KUSHLA-BROWN SUBDIVISION

APPLICATION NUMBER 4 DATE August 1, 2019

REQUEST Subdivision

DETAIL SITE PLAN

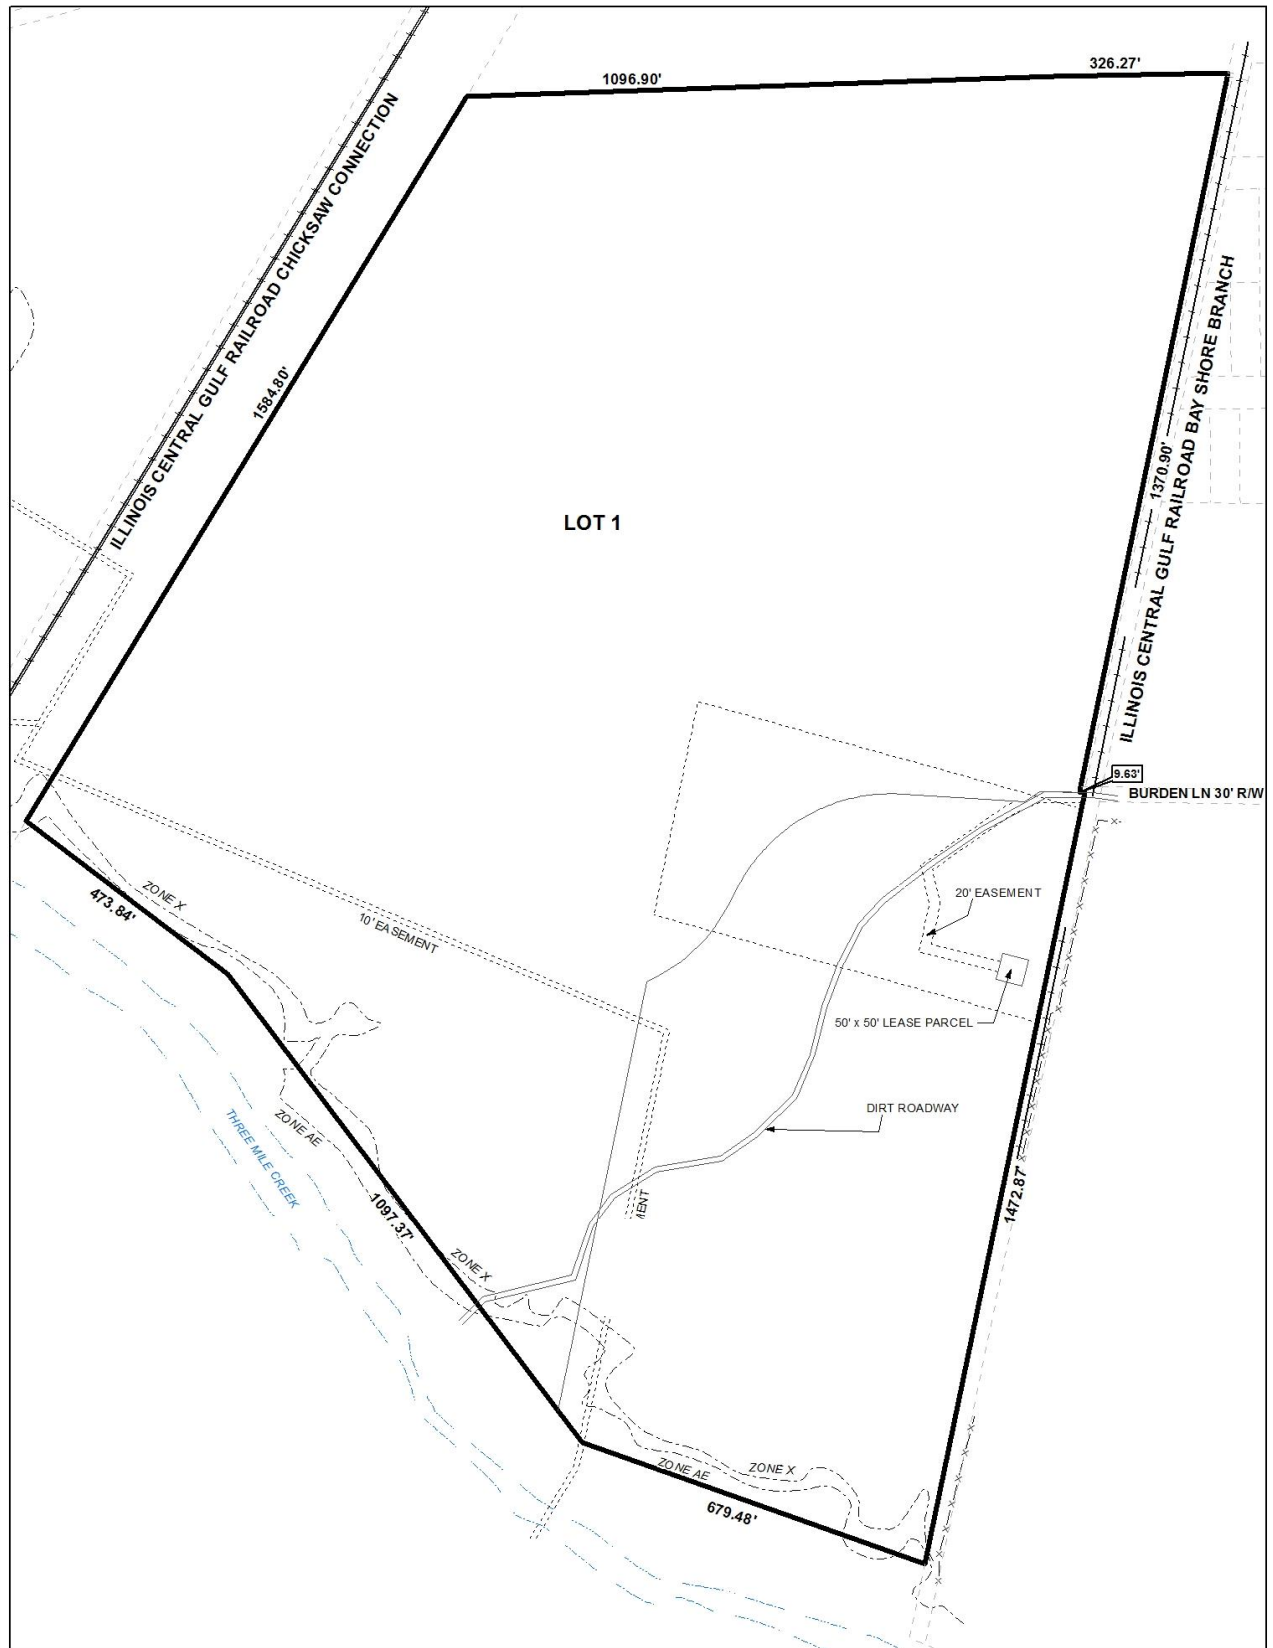
- B. Revise the boundary line of the proposed subdivision to be distinct and not the same color and thickness as other parcel lines.
- C. Show and label the POB for LOT 1.

- D. Revise the Vicinity Map to show the correct vicinity.
- E. Provide a signature block for each and every owner. The application indicates that there is currently more than one (1) owner.

- F. National Wetlands Inventory (NWI) mapping, as shown on City of Mobile GIS, indicates that there is potential for wetlands within the property or properties shown on this plat. Show and label the delineated wetlands, or provide a note stating that the wetlands shown on this plat are scaled from the NWI data and have not been delineated.

- H. Show and label the MFFE (Minimum Finished Floor Elevation) on each lot that contains an AE, V, or X (shaded) flood zone designation.
- I. Provide the Surveyor's, Owner's (notarized), Planning Commission, and Traffic Engineering signatures.

The plat indicates a 10' sewer line easement in the Southwest portion of the site. Therefore, a note should be required on the Final Plat stating that no structure may be constructed or placed within this easement.

The vicinity map provided on the preliminary plat depicts an area along Todd Acres Drive in the Theodore area of the city. This should be corrected to accurately depict the Crichton area where the subject site is actually located.

- 1) retention of the current right-of-way width of Burden Lane on the Final Plat;
- 2) revision of the plat to depict a 25' minimum building setback line blocked-out at the West terminus of Burden Lane;

- 3) retention of the lot size label in both square feet and acres, or the furnishing of a table on the Final Plat providing the same information;
- 4) placement of a note on the Final Plat stating that no structure may be constructed or placed within the sewer line easement;

- 5) placement of a note on the Final Plat stating that no further resubdivision of the lot is allowed until Burden Lane is developed to City standards, or additional frontage on a public street is provided;

- 10) correction of the vicinity map on the Final Plat to depict the site in the Crichton area of the city.
